SUBSURFACE WASTEWATER DISPOSAL SYSTEM APPLICATION

Town Or Plantation	Augusta
Street Subdivision Lot #	Sunrise Circle

AUGUSTA PERMIT # 369 TOWN COPY

SUBSURFACE WASTEWATER DISPOSAL PLAN

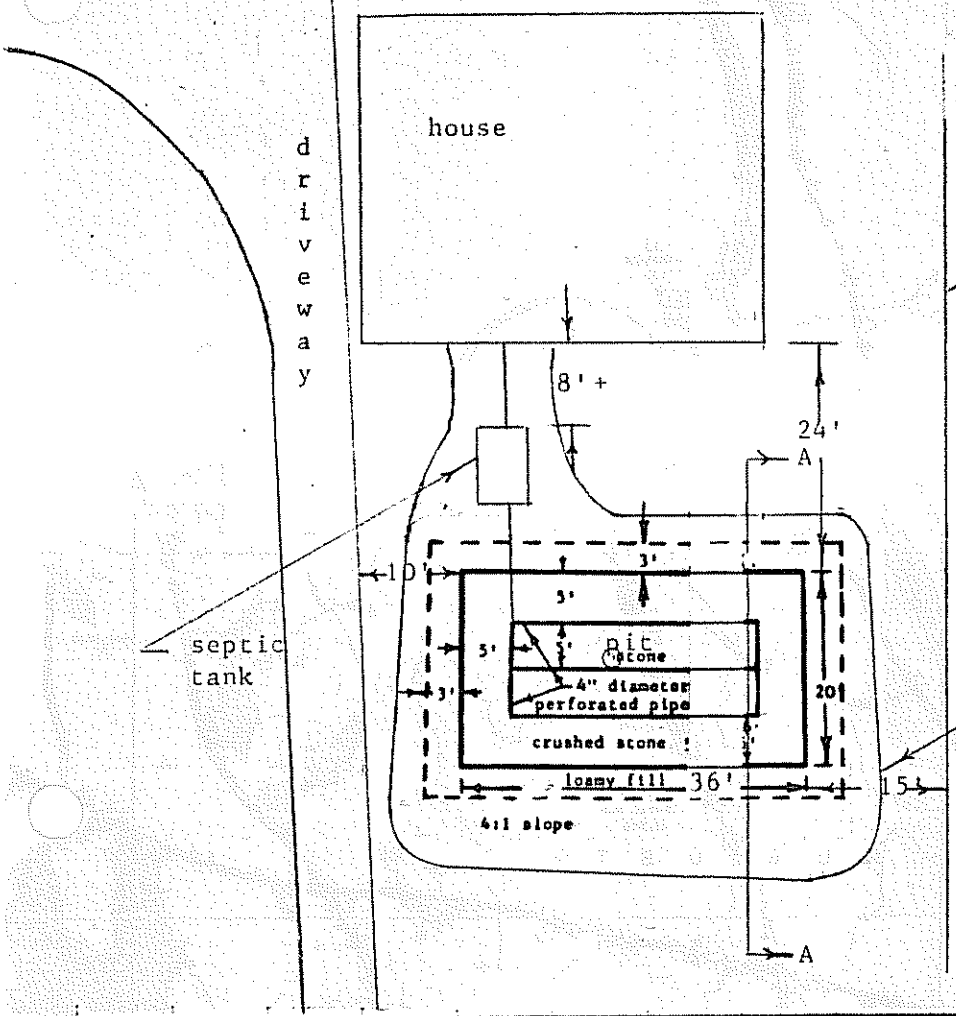
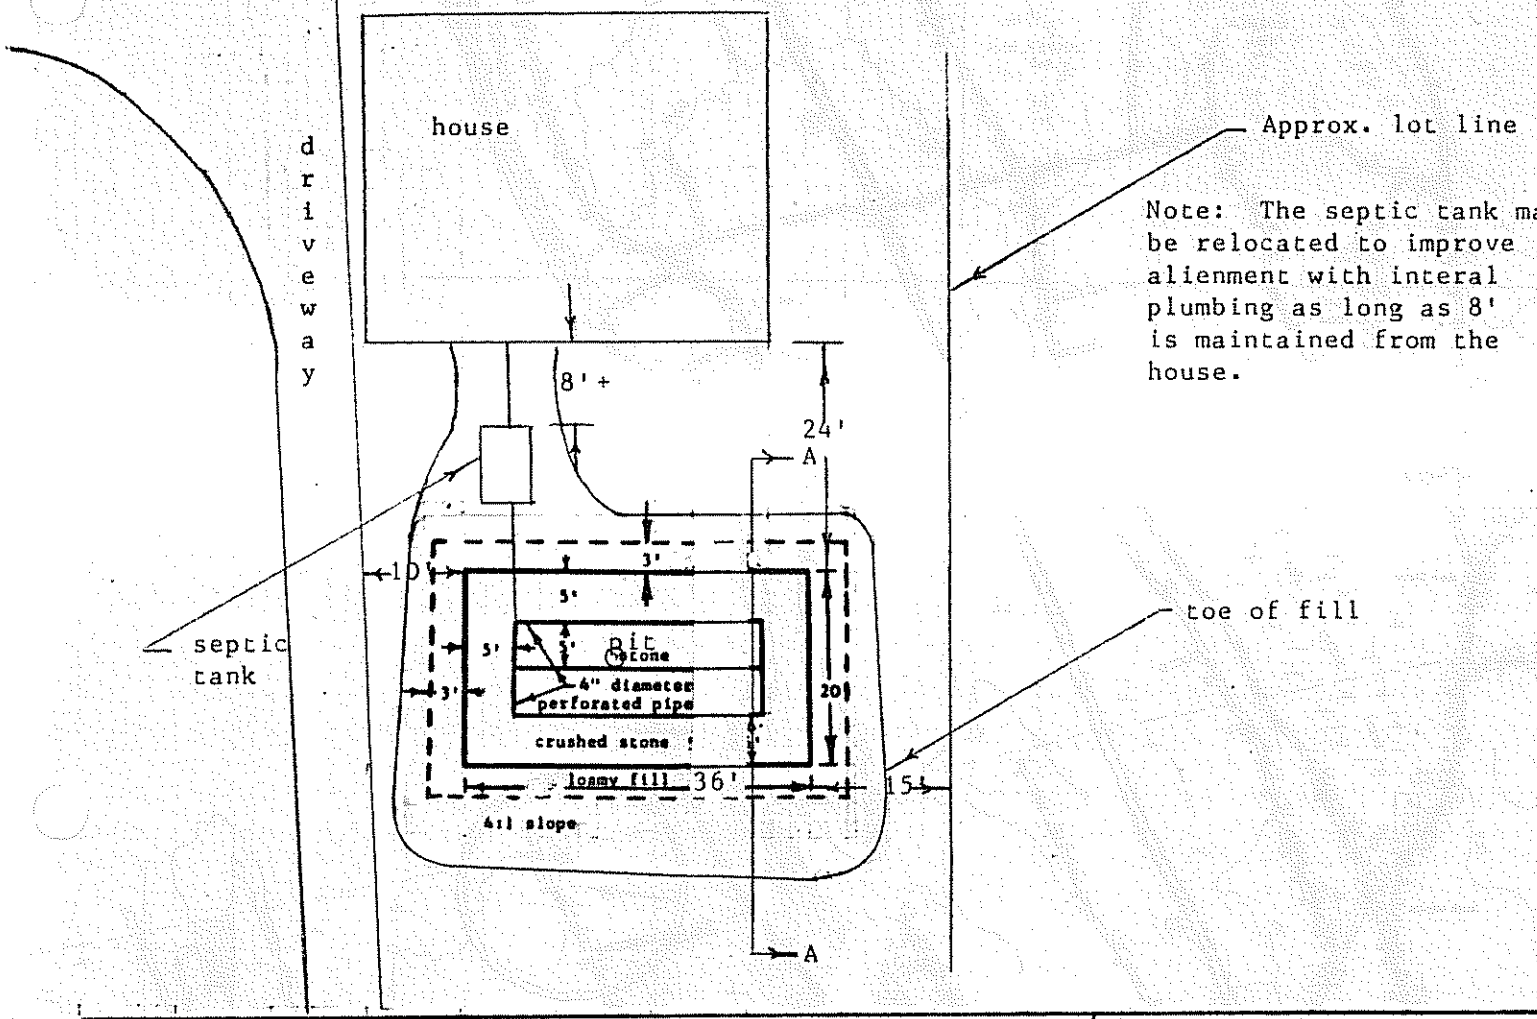
REVISION: Due to the location of water pipe enterintg the home, the bed must be rotated 90° from it's location shown on this plan. Set the bed at the upper left corner and run the short dimension parallel with the house and the long dimension toward the street. maintain the same elevations, or they may be dropped a few inches (6" max.) so long as runoff from the roof doesn't cross the bed.
